Your Ref
BR/324/17/PL
Our Ref
PLAN-023717
Date
24/07/2018

Proposal: Residential Development: restoration of 2 houses and attached commercial annexe to pair of semi-detached houses, replacement of bungalow with pair of semi-detached houses, development of land to rear for eight flats (6 x 2 bed & 2 x 1 bed).

Site: 283-285a Chichester Road, Bognor Regis, PO21 5AH.
BR/324/17/PL

Screen Print

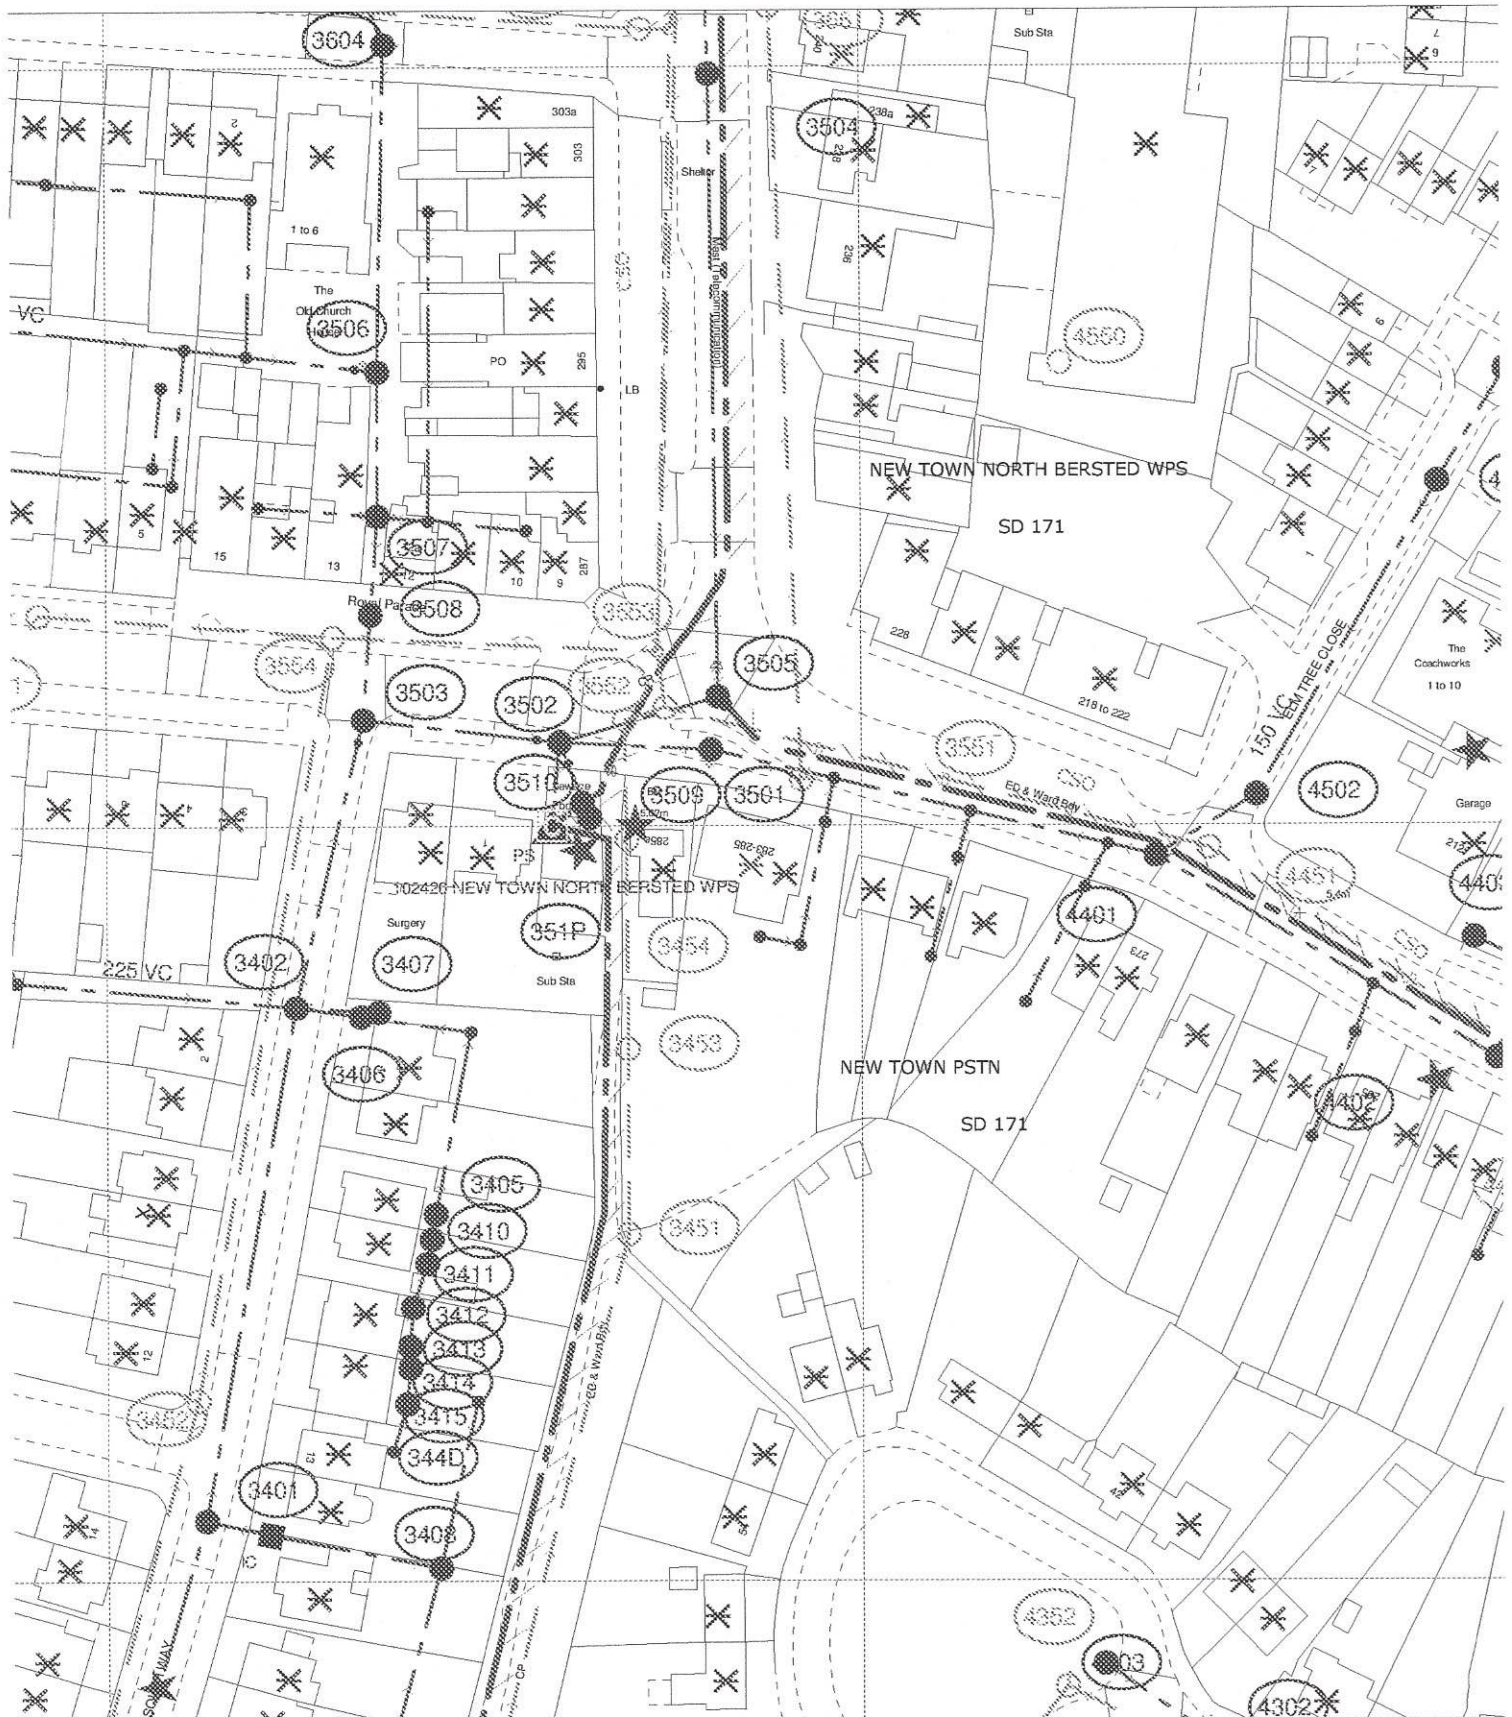
Please find attached a plan of the sewer records showing the approximate position of foul and surface water sewer crossing the site. The exact position of the foul and surface water sewers must be determined on site by the applicant before the layout of the proposed development is finalised.

1. The surface water sewer requires a clearance of 3 metres either side of the sewer to protect it from construction works and allow for future access for maintenance.
2. The foul sewer requires a clearance of 3 metres either side of the sewer to protect it from construction works and allow for future access for maintenance.

3. No development or new tree planting should be located within 3 metres either side of the external edge of the surface water sewer.
4. No development or new tree planting should be located within 3 metres either side of the external edge of the foul sewer.
5. No soakaways, swales, ponds, watercourses or any other surface water retaining or conveying features should be located within 5 metres of a public sewers.
6. All other existing infrastructure should be protected during the course of construction works.
